PRODUCT/PROCESS CHANGE NOTICE (PCN)

PCN #: A1301-08 Product Affected: 3.0mm x 3.0mm VFQFPN-20 4.0mm x 4.0mm VFQFPN-24 4.0mm x 4.0mm VFQFPN-28 (Refer to Attachment 2) Date Effective: May 5, 2013	DATE: February 5, 2013	MEANS OF DISTINGUISHING CHANGED DEVICES: <input type="checkbox"/> Product Mark <input type="checkbox"/> Back Mark <input type="checkbox"/> Date Code <input checked="" type="checkbox"/> Other <div style="margin-left: 20px;">Assembly lot marked on the device provides traceability to the material used</div>
---	--------------------------------------	---

PCN Type: Assembly Process and Material Change

Figure 1: Illustration of Interposer Inserted between top die and bottom die (Top View)

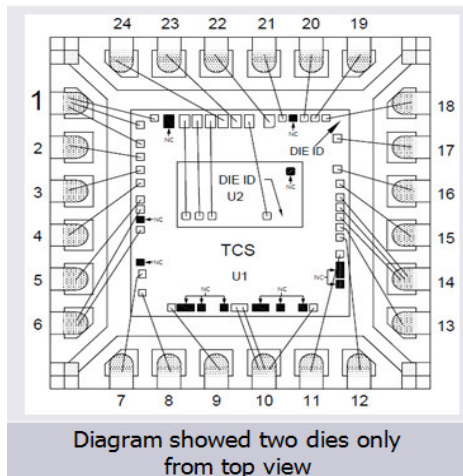
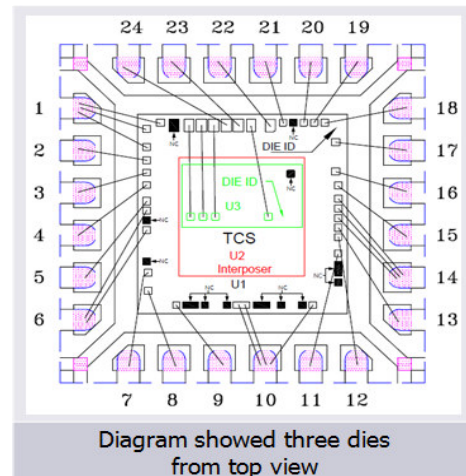
This notification is to advise our customers that IDT has successfully completed the qualification of stack die assembly with interposer. An interposer will be added in between the top die and the bottom die to improve assembly yield.

The die attach material for the top die will change to NEX-130SB-25 and for the bottom die to 8200T.
